DRAWN C. BROS 3-1-82	MUSIC MAN INC. ANAHEIM, CA.
CHECKED T. WALKER	RD-50 AMPLIFIER SCHEMATIC DIAGRAM
DESIGNED T. WALKER	RD-50B BOARD
APPROVED M.W.	SCALE DWG. NO. 5004
	SHEET 1 OF 1 REV. D

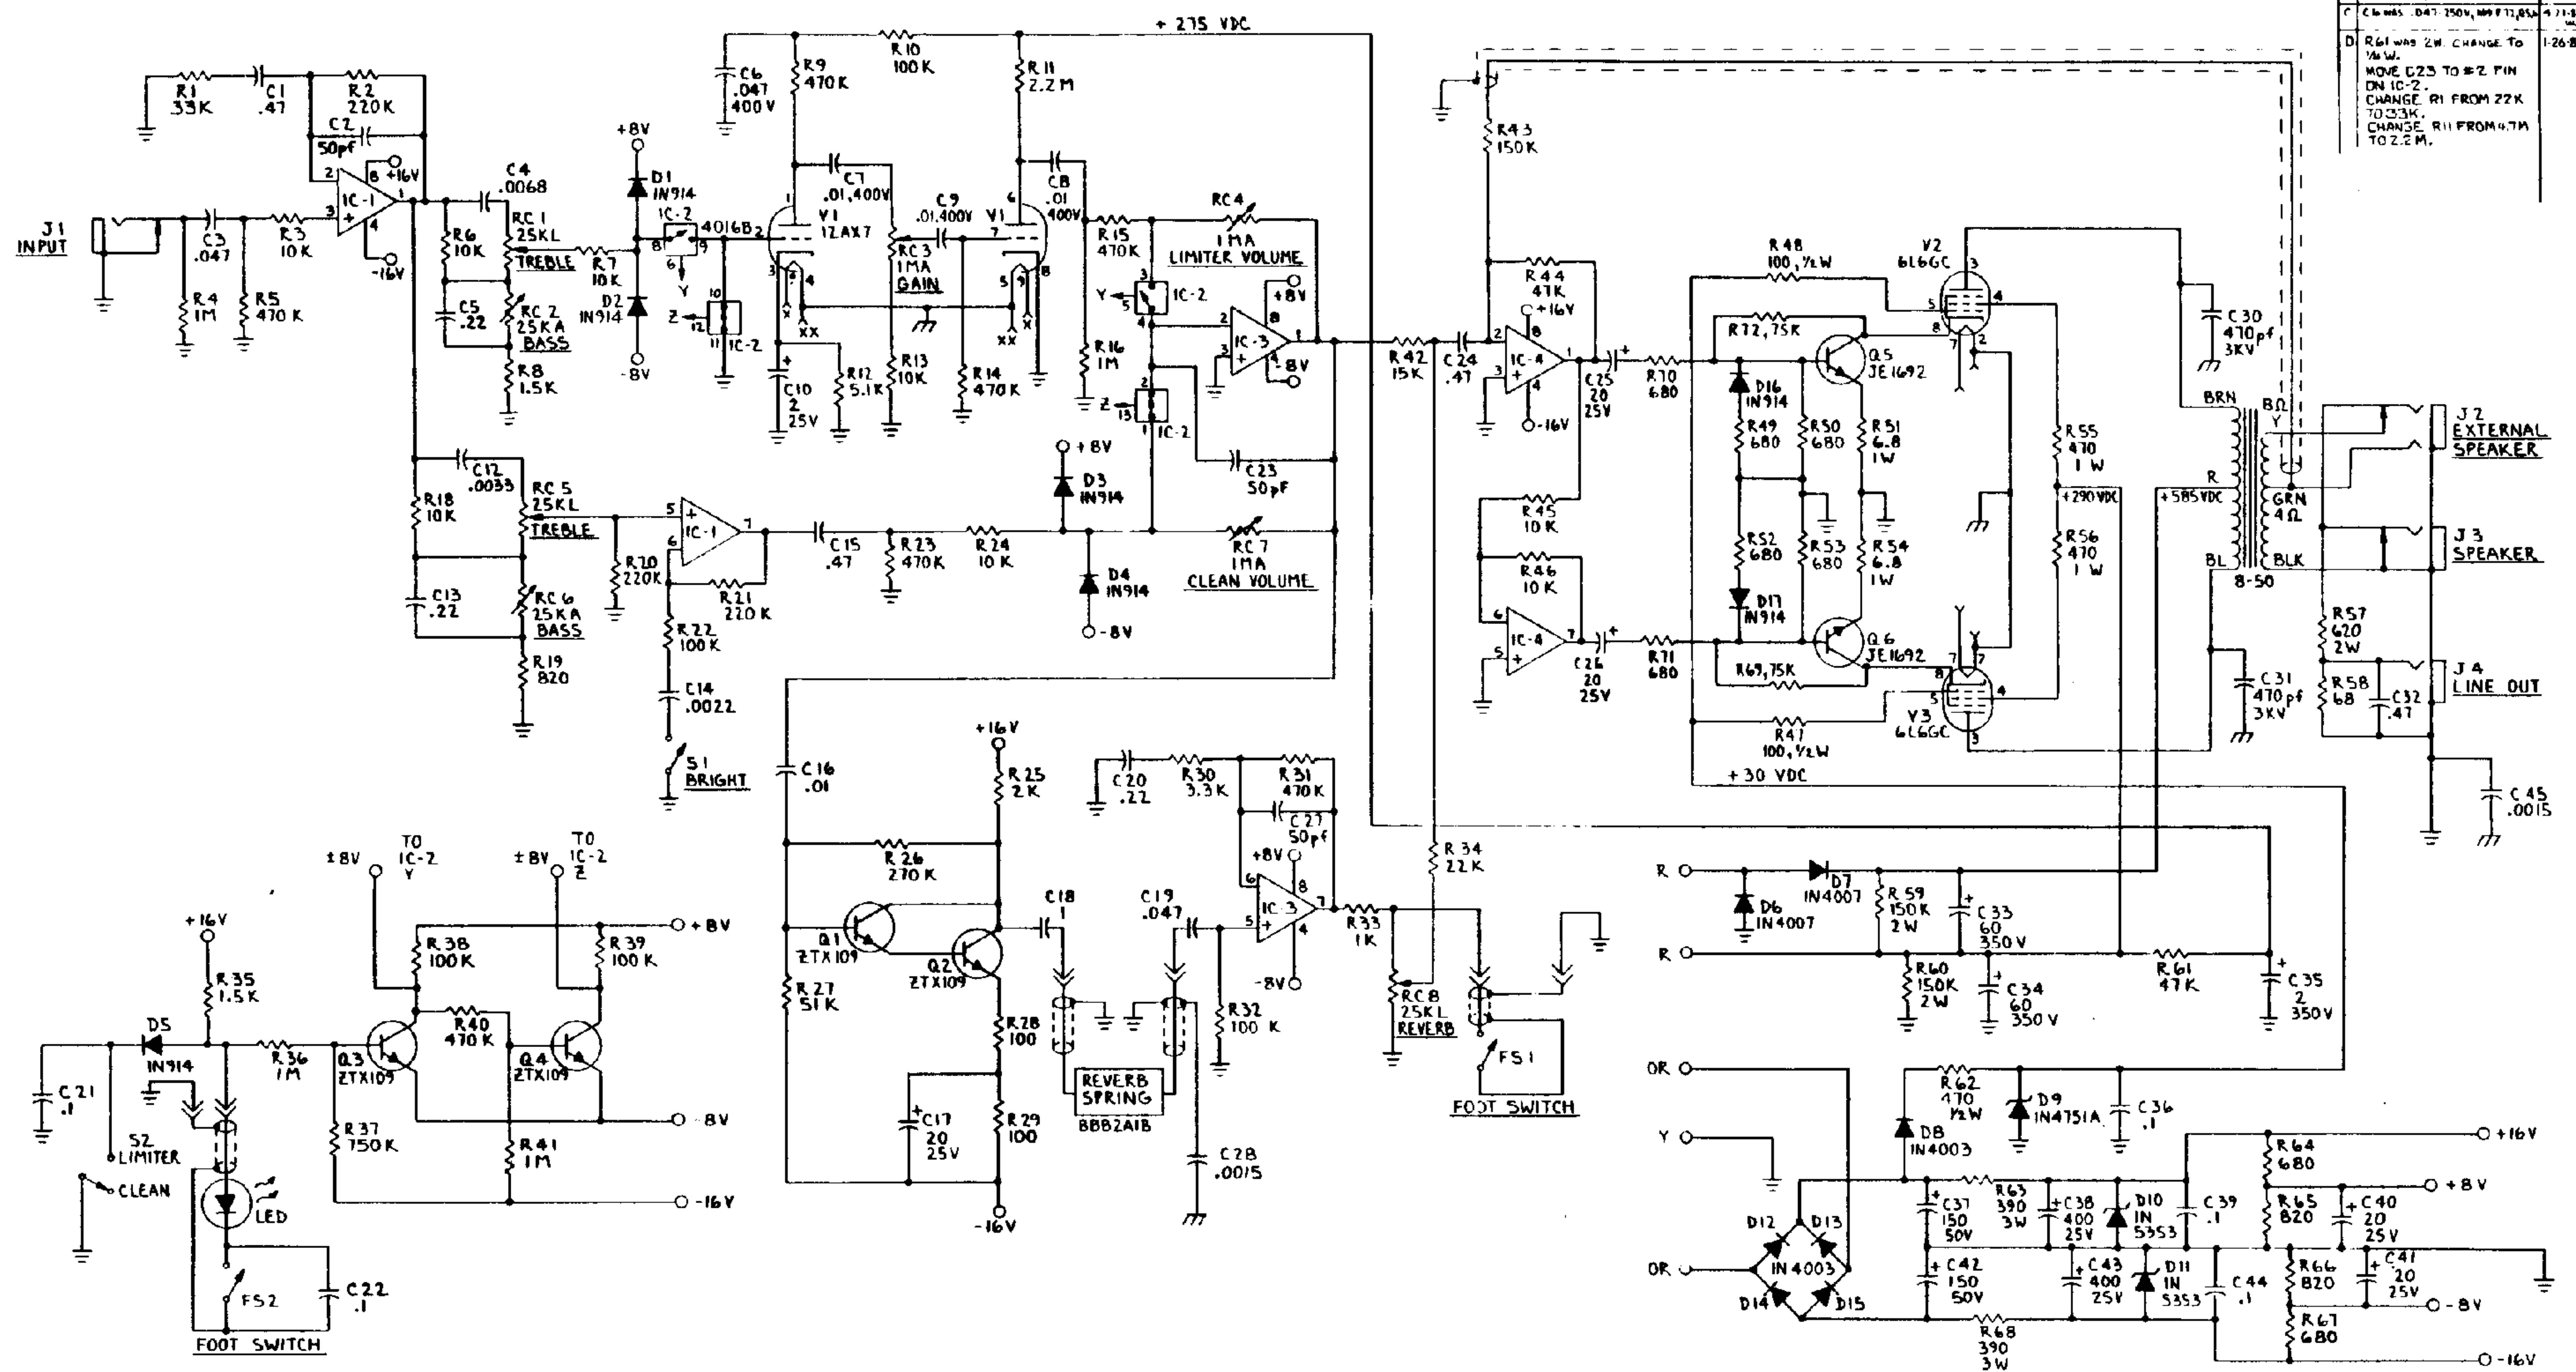
REVISION	DATE
A. REPAIR INTER-TONE FREQUENCY DIVIDER SECTION - FOR "MPS" CONDITION SEE 5004 NE	11-11-80
B. ADD C 45; 0.0015 MFD 50V	1-30-81
C. C6 WAS .047 250V, NOW 1.5K	4-11-81
D. R4 WAS 2W. CHANGE TO 1W. MOVE C23 TO #2 PIN ON IC-2. CHANGE R1 FROM 22K TO 20.3K. CHANGE R11 FROM 4.7M TO 2.2M.	1-26-82
